Access Compliance Report

Public Rights-of-Way

(Curb Ramps)

Intersection ID: 7457	Main Street: CANTERWOOD_DR	Cross Street: ELGYWOOD_LN	Location: SW
ADA ID: 0B9165D5F70D	Ramp Type: Para	Initial Pass/Fail: Fail	Overall Compliance: No
Severity Score: 12.5			
Codes/Mitigation Info/Possible Solution		Field Measurements/Component Compliance

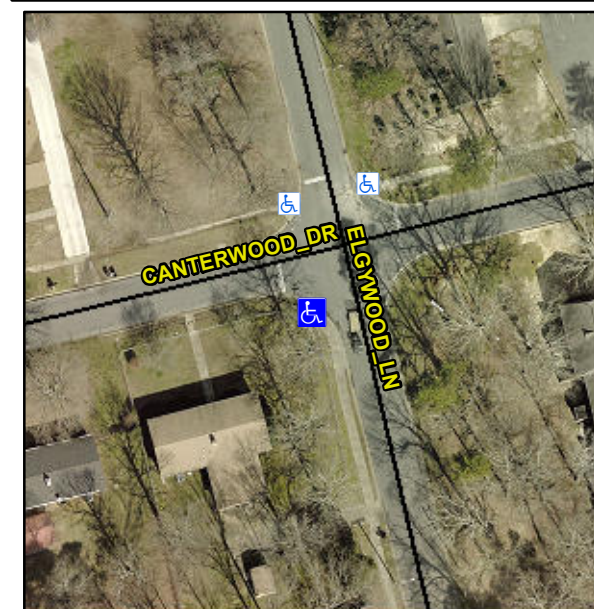
LT RP < 5%, NO RT SW, CURB GAP 1.0

R304.3.2

Remove & Replace Entire Ramp.
